S U B M I S S I O N: Luong-Le  
a written submission by way of objection to DA 2020/0442

Re:  
231 Whale Beach Road Whale Beach 2107  
DA 2020/0442

WRITTEN SUBMISSION: LETTER OF OBJECTION  
Submission: Luong-Le

*Demolition of the existing Apartment and Retail Building and Construction of a New Shop Top Housing Development*

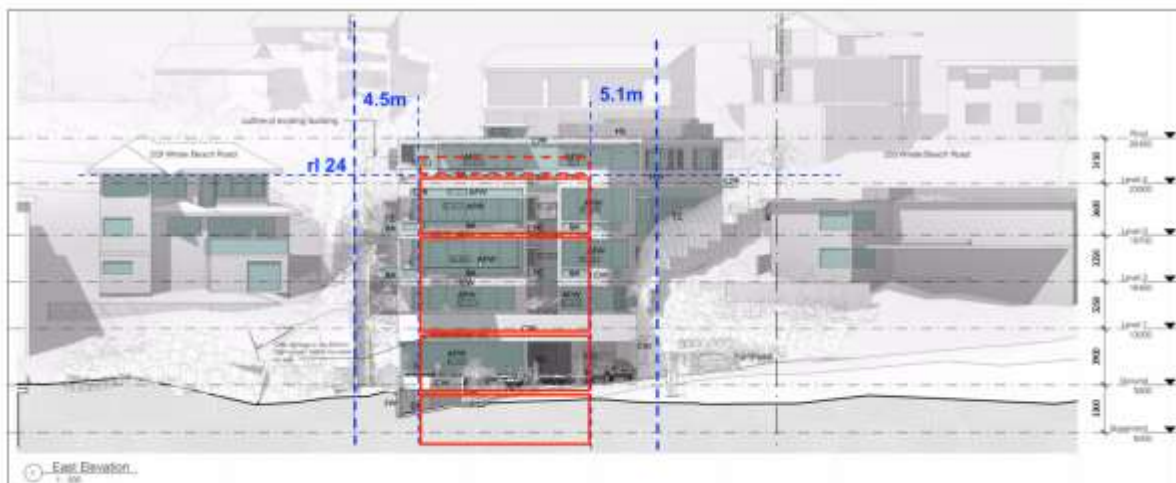
The proposed Storey Heights are excessive to ADG guidelines, and these could decrease to:

Allowing for 2 x Commercial @ 3.6m [7.2m] + 3 x Residential @ 3.0m [9.0m] + 1 Carpark @ 2.7m, the overall building height would require 18.9m building height above the basement slab. To achieve a RL 24.0 wall height to match neighbouring sites, the Basement would need to be lowered to RL 5.1m.

An amended scheme could deliver:

- Basement RL 5.1m Carparking, provide additional double stackers to increase carparking
- Ground RL 7.8m Commercial & Carparking
- First RL 11.4m Residential
- Second RL 14.4 Residential
- Third RL 17.4 Residential
- Fourth RL 20.4 Commercial [Back of pavement WBR @ RL 20.75 and 21.5 balustrade not to extend past 13m contour]
- Roof RL 24.0 Roof [not to extend past 15.5m contour, preferably a greater setback to reduce the bulk]
- Plant RL 25.2 Plant, maximum permissible of any plant or lift over run, positioned at western side facing Whale Beach Road to avoid view loss.

The amended sectional profile would present wall heights that align with the wall heights at #229 Whale Beach Road at RL 24.0.

Plant Screens above the roof should be conditioned at a maximum of 1.2m, giving a maximum height of RL 25.2, being more appropriate massing to the roof forms within #229 Whale Beach Road.

The screens should have side setback from the roof edge by 3m. No part of the building or roof plant should be above RL 25.2.

Figure 3F.3 New development adjacent to existing buildings should provide adequate separation distances to the boundary in accordance with the design criteria

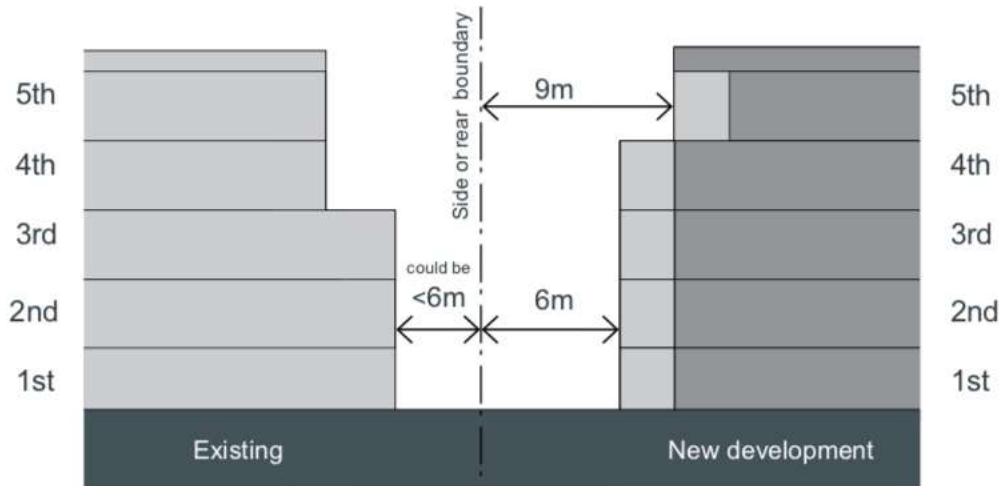
Non-compliant to controls

ADG: 6m side & rear setback requirement v Proposed 1.8m

Council should insist on a 6m side setback to ADG controls, or a dimension closer to that control.

## Boundary conditions

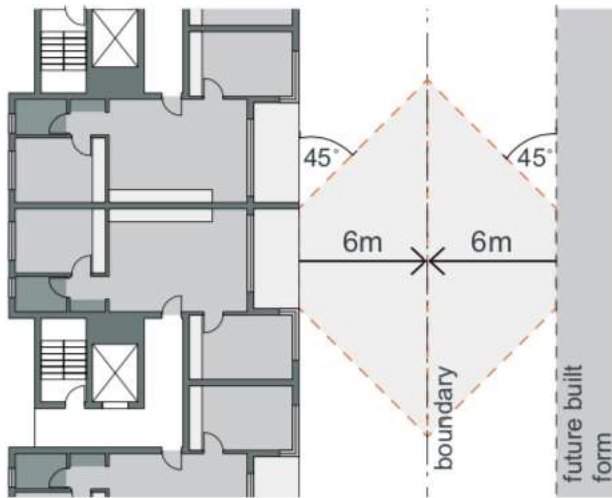
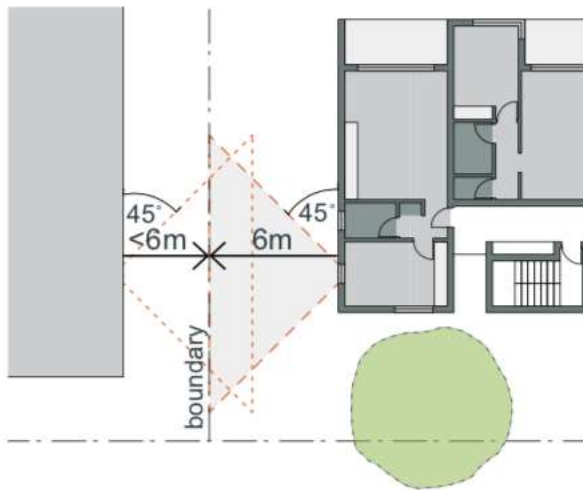
ADG: Control 6m boundary condition setback v Proposed 1.8m
